SUBMISSIONS REPORT

Jindera Solar Farm

March 2020

Project Number: 17-323

Figure 3-2 Updated constraints map

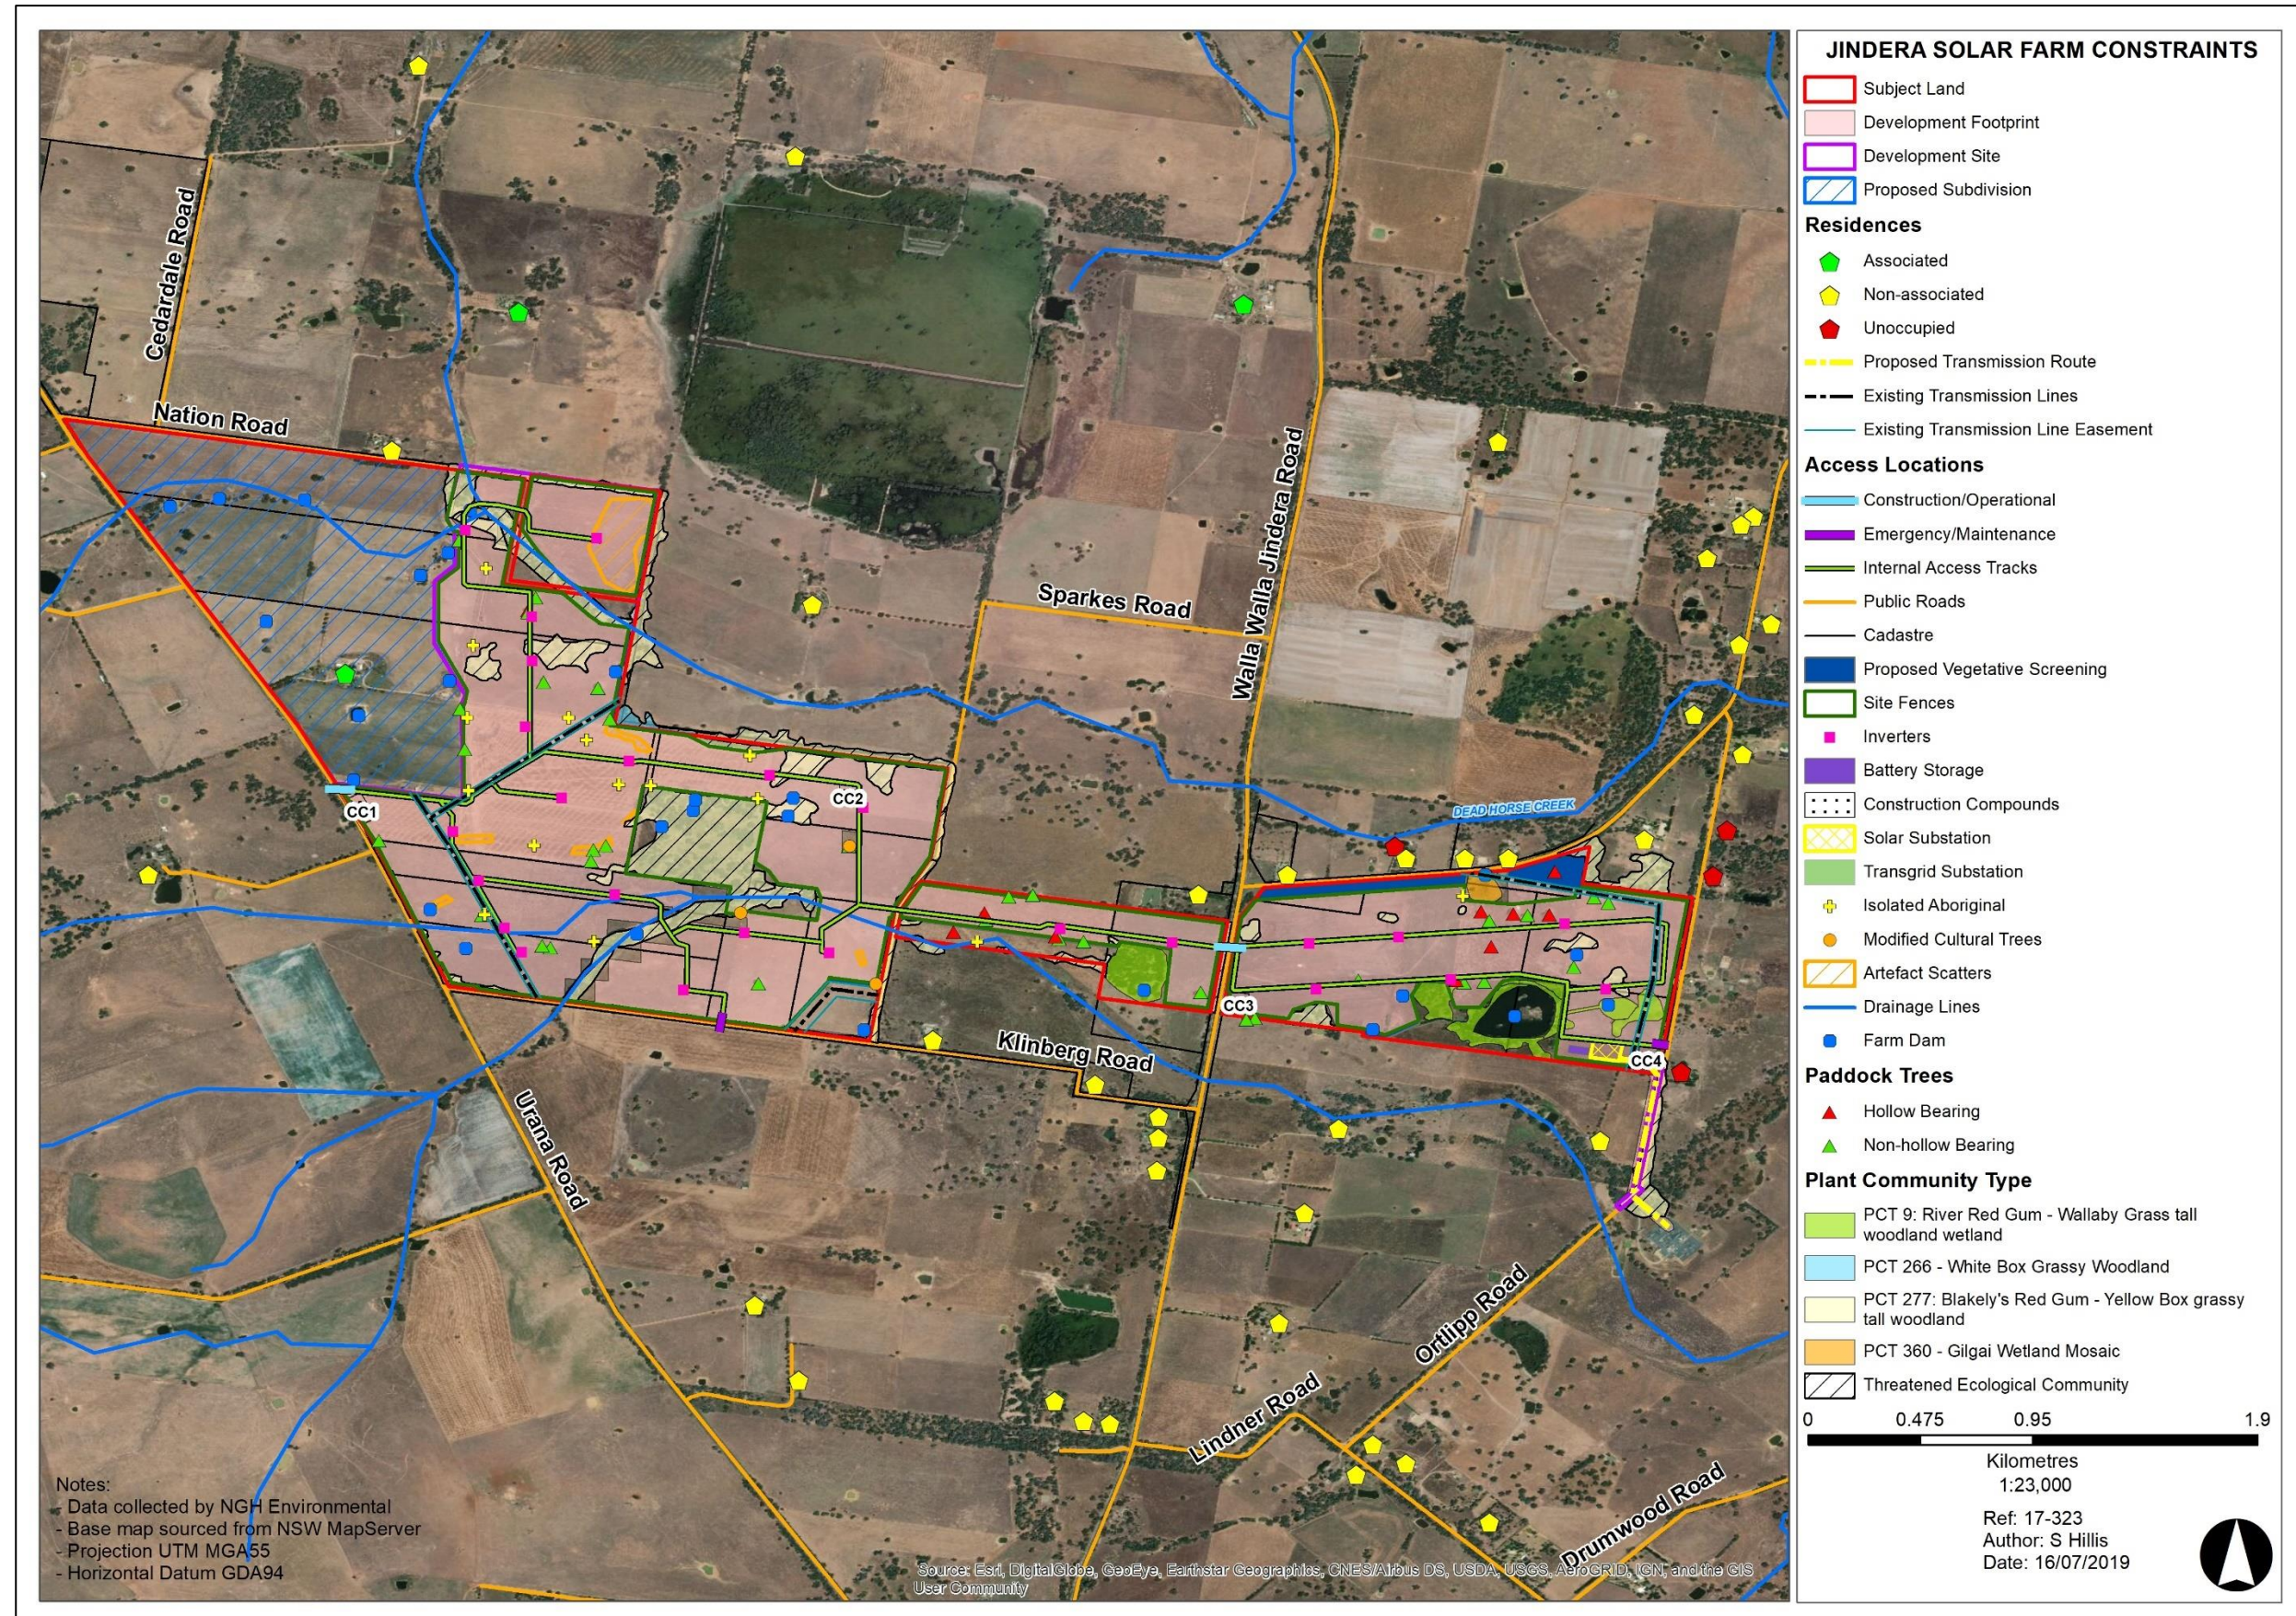
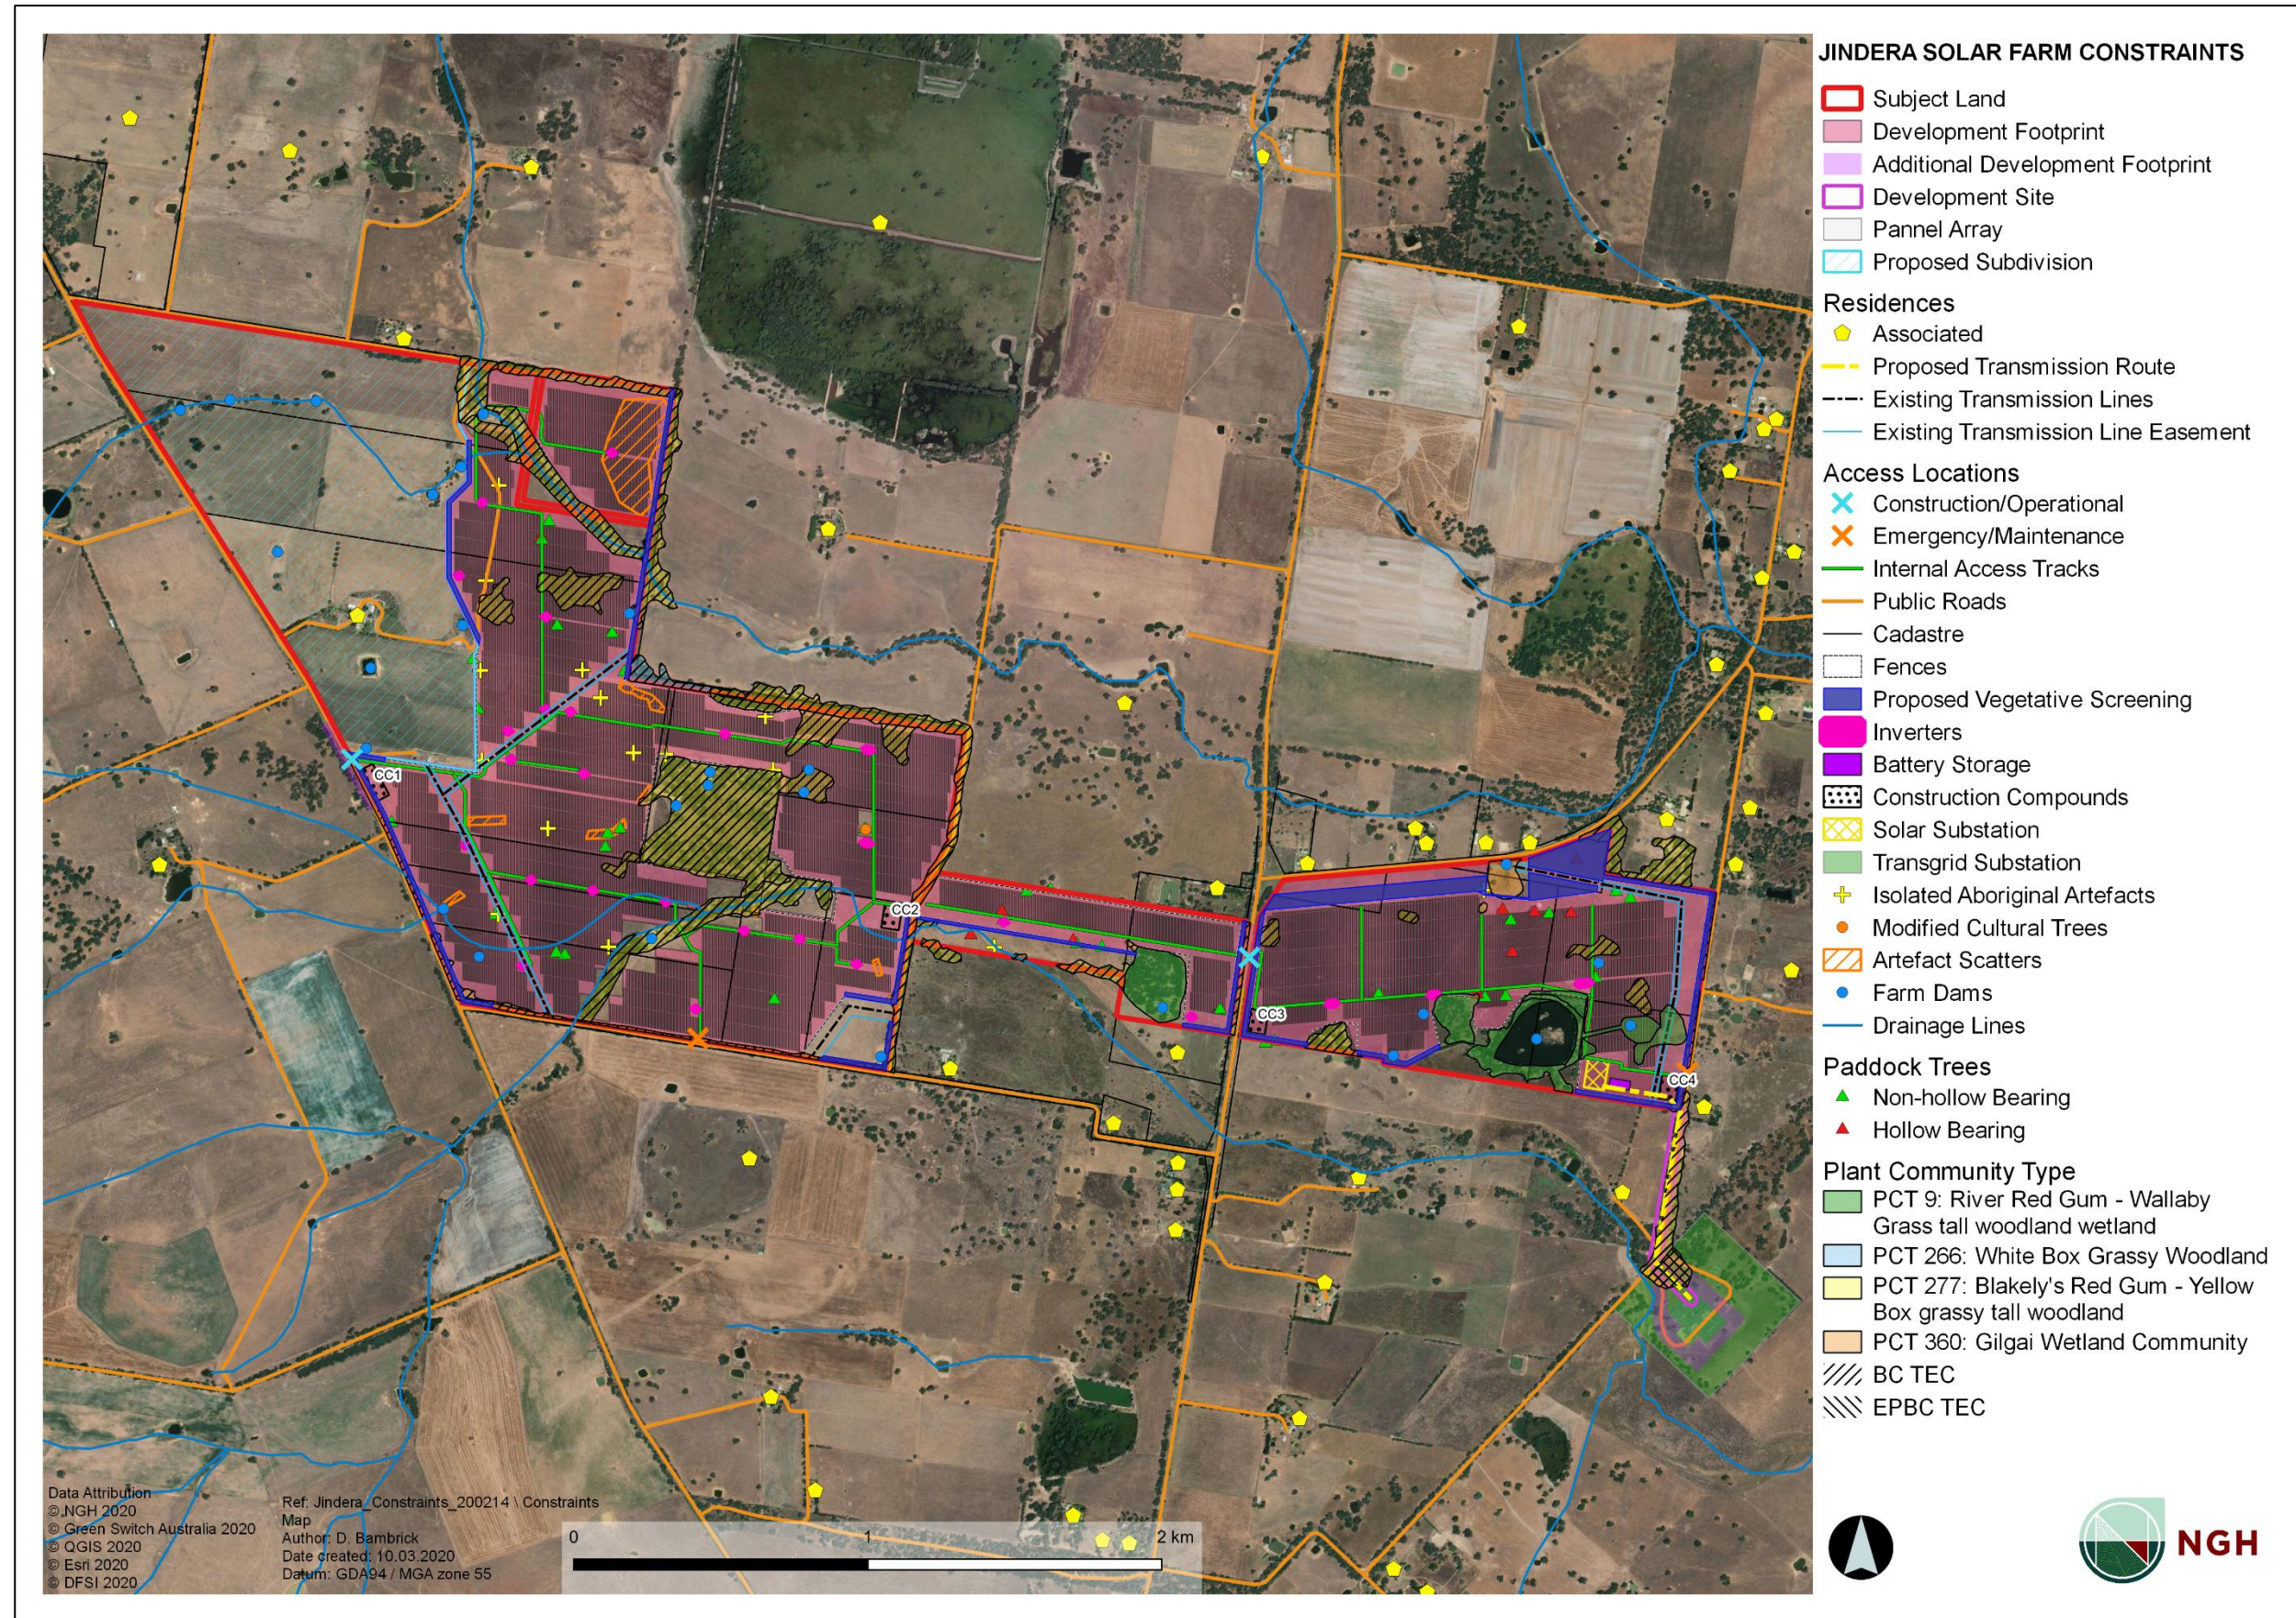
The original proposed infrastructure map (Figure 2-1) demonstrated avoidance of sensitive features on the site. An updated layout giving consideration to submissions is detailed in Figure 3-2.

- Agreement of Voluntary Planning Agreement and Community Fund.
- Increase in separation buffer and vegetation screening on Glenellen Road.
- Additional vegetation screening site wide.
- Refined PV layout and inverter positioning.
 - Greater setback for PV Panels from neighbouring boundaries.
 - Refinement of inverters solution.
 - Quieter inverters.
 - Strategic placement of trackers.
 - Commitment to 30 m setback for panels to neighbouring property boundary.
- Commitment to remove cables and all underground infrastructure at decommissioning.
- Clarification of proposed works on Ortlipp Road.
- Additional investigation works within the TransGrid substation and proposed site access points.
- Further protection for Squirrel Gliders.
